2006 INTERNATIONAL FIRE CODE DOCUMENTATION

IBC - MEANS OF EGRESS

Diagram 1 – TYPICAL WALL SECTIONS AT STAIRS IN PLAN VIEW

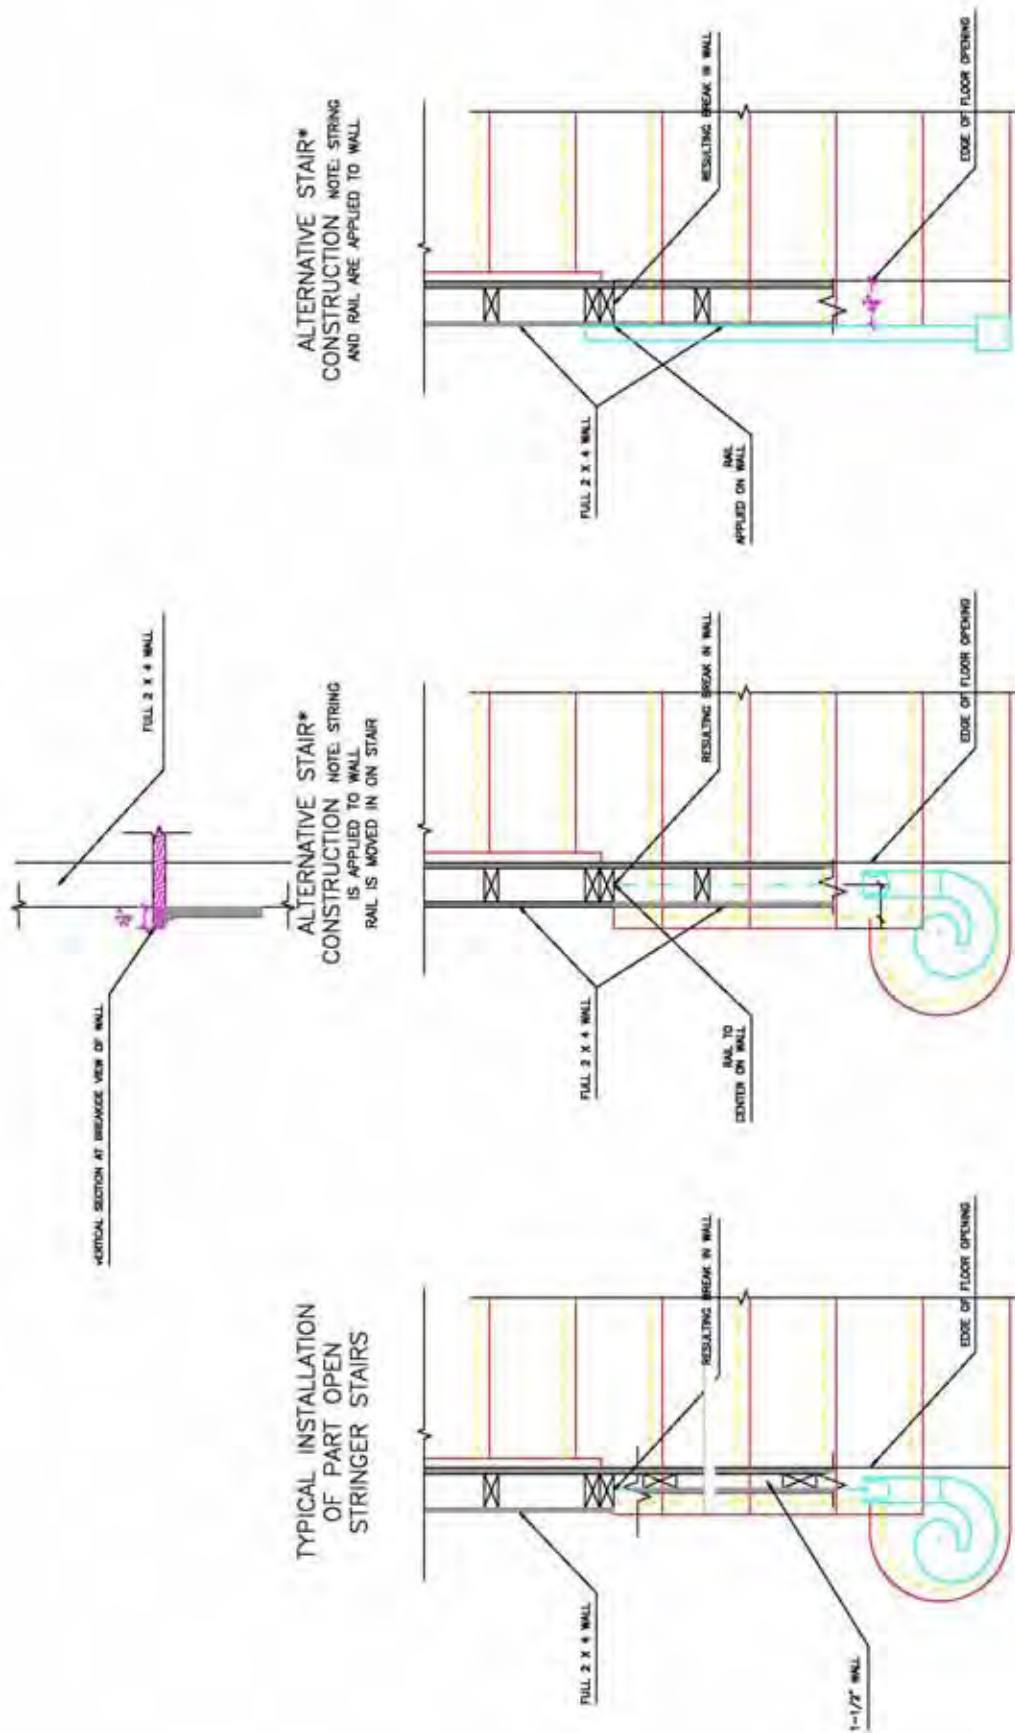
R311.5.2 Headroom. The minimum headroom in all parts of the stairway shall not be less than 6 feet 8 inches (2036 mm) measured vertically from the sloped plane adjoining the tread nosing or from the floor surface of the landing or platform on that portion of the stairway that is available for placement of the foot in ascent or descent.

Figures 1, 2, & 3 show common walk line locations as determined by the modification. The walk line, balusters, post, and tread nosings are in black. The wall is green and the skirt board or finish stringer is in red.

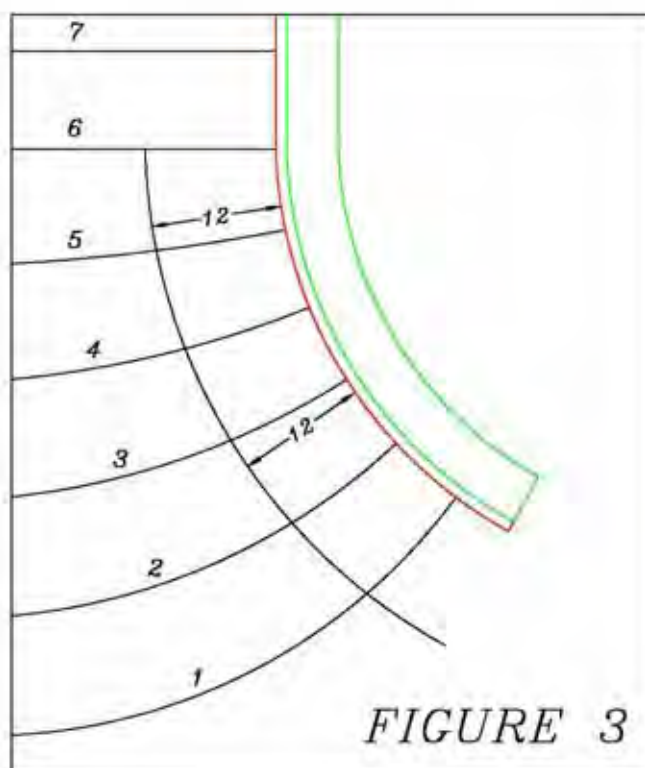
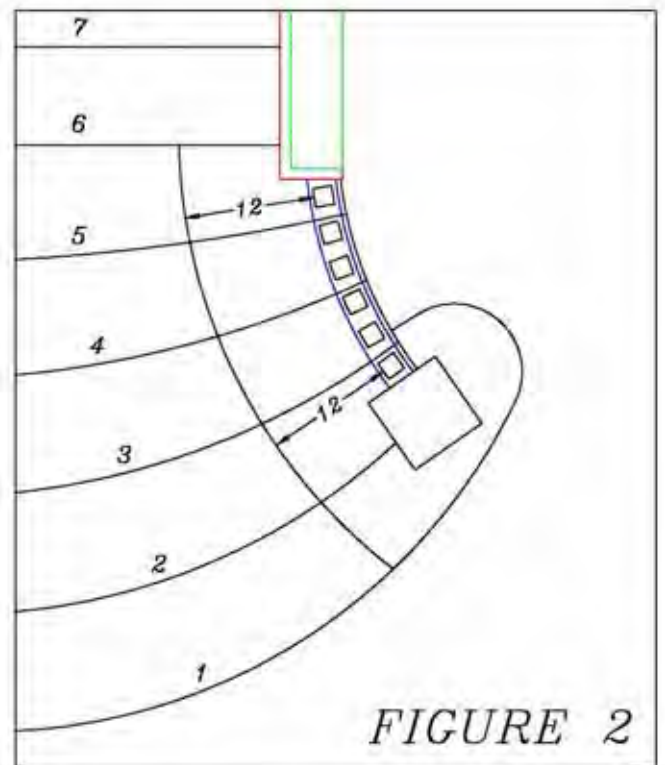
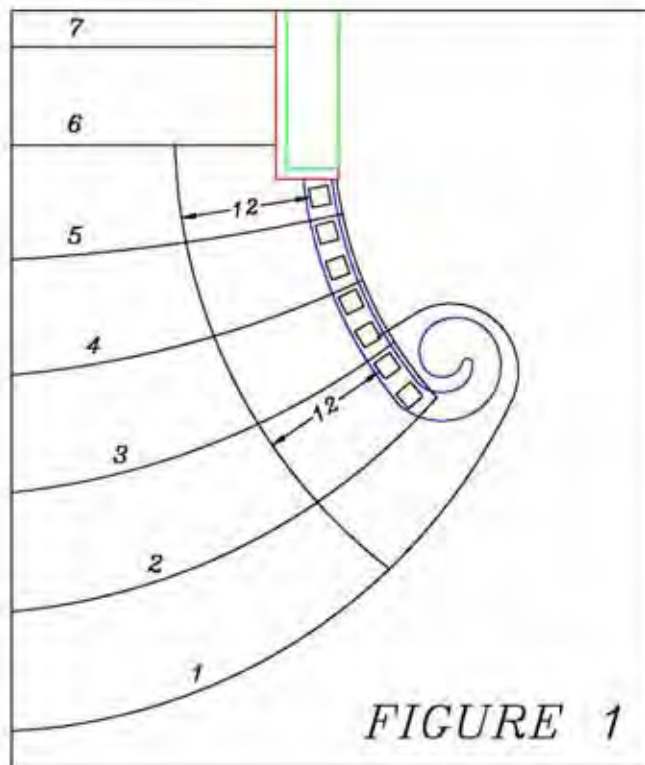
The IRC committee had issues with the terminology "used for placement of the foot..." and that has been stricken. The new section titled walk line states clearly and specifically how to locate the walk line at winder treads where it is used to determine the tread depth of winder tread(s) that provide for turning of the stair's direction of travel. This line of travel across winders is a curved path and the walk line established for regulation must parallel it. The term concentric is used because it more accurately describes the geometry of parallel arcs or curves sharing the same center. This separate section substantiates this essential element required in the design and construction of stairs that turn. It further provides clarity for regulating its location that is not subject to the wide interpretation of the present code and thereby allows for the direct reference to walk line in subsequent sections of the code. Please also see the original supporting statement for further substantiation of these changes.

Locate the winder treads in the turn of the stair.

1. Locate the side of the stair where the winder treads are narrower
2. Establish the widest point of clear width of the stair at the surface of the winder or run of adjacent winders
3. Measure across the stair width 12 inches from the object that restricts the clear width at the tread surface
4. Measure tread depth between the intersections of the nosings with the walk line.

R311.5.2.3 Walk line. ~~The walk line is the line of travel used to provide for uniform layout of the tread depths in the design and regulation of flights with winder treads. The walk line shall be parallel to the side of the flight where the treads are narrowest and located 12 inches (305 mm) from the point of minimum tread depth used for placement of the foot on the flight in ascent or descent. The walk line across winder treads shall be concentric to the curved direction of travel through the turn and located 12 inches (305 mm) from the side where the winders are narrower. The 12 inch (305 mm) dimension shall be measured from the widest point of the clear stair width at the walking surface of the winder. If winders are adjacent within the flight, the point of the widest clear stair width of the adjacent winders shall be used.~~

R311.5.3.2 Tread depth. The minimum tread depth shall be 10 inches (254 mm). The tread depth shall be measured horizontally between the vertical planes of the foremost projection of adjacent treads and at a right angle to the tread's leading edge. The greatest tread depth within any flight of stairs shall not exceed the smallest by more than 3/8 inch (9.5 mm). Winder treads shall have a minimum tread depth of 10 inches (254 mm) measured between the vertical planes of the foremost projection of adjacent treads at the intersections with the walk line. Winder treads shall have a minimum tread depth ~~used for placement of the foot ascent or descent~~ of 6 inches (152 mm) at any point within the clear width of the stair. Within any flight of stairs, the largest winder tread depth at the walk line shall not exceed the smallest winder tread by more than 3/8 inch (9.5 mm).

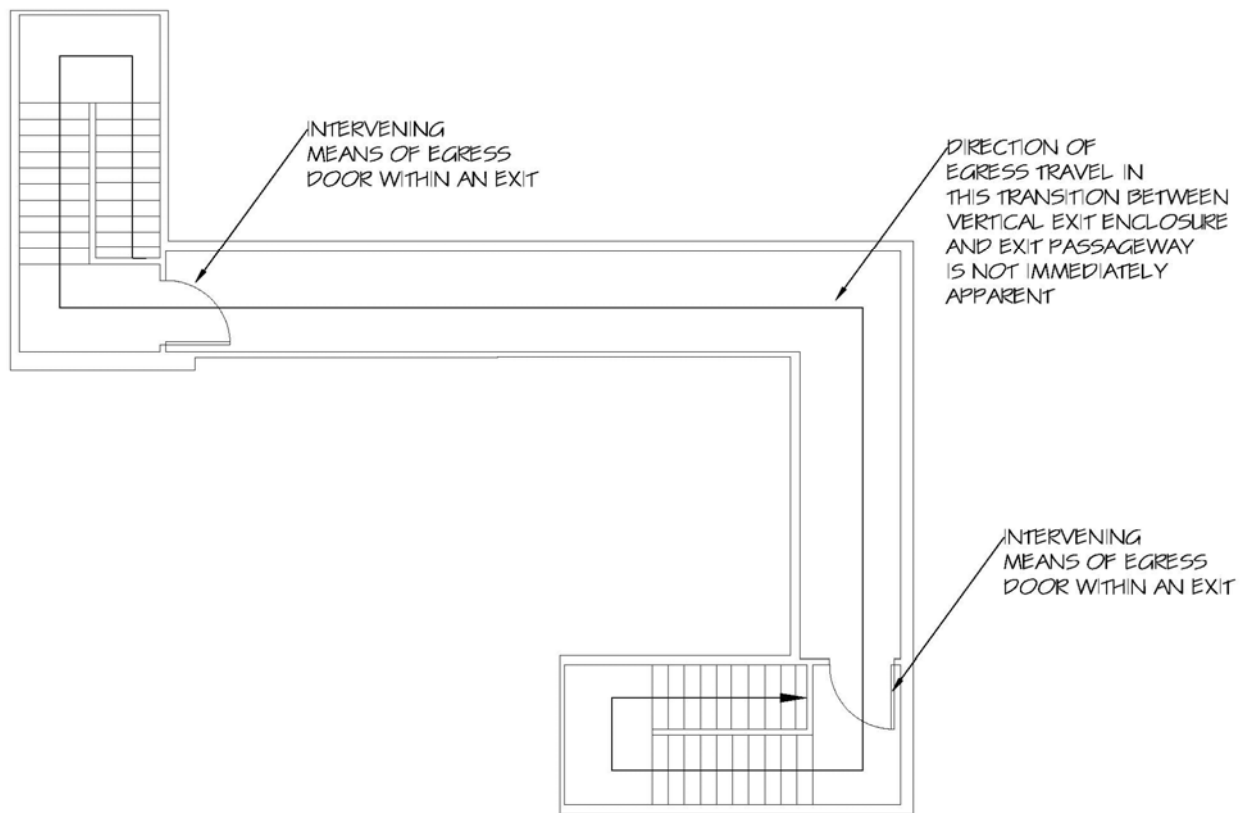
Reason: Section 1011.1 requires exit signs along the exit access to help occupants to reach the exits. Typically, once the occupants reach the exits, exit signs are not required within the exits. However, in buildings with more complicated egress layout, it is possible that the direction of egress travel within the exits may not be immediately apparent to the occupants. For example, a vertical exit enclosure on the north side of a building may transition into a horizontal extension in the form of either an extended landing/corridor or an exit passageway with intervening means of egress doors on the 15th floor before continuing down into the staircase on the south side. The path of egress might involve turns with extended distances. In such cases, it is important to provide clear egress direction for the occupants within the exits.

The report from the 2003 World Trade Center Building Code Task Force identified the problem of clarity or "readability" of travel within exit enclosures, and in response to the 1993 and 2001 World Trade Center incidents, recommended additional exit signs within the exit enclosures.
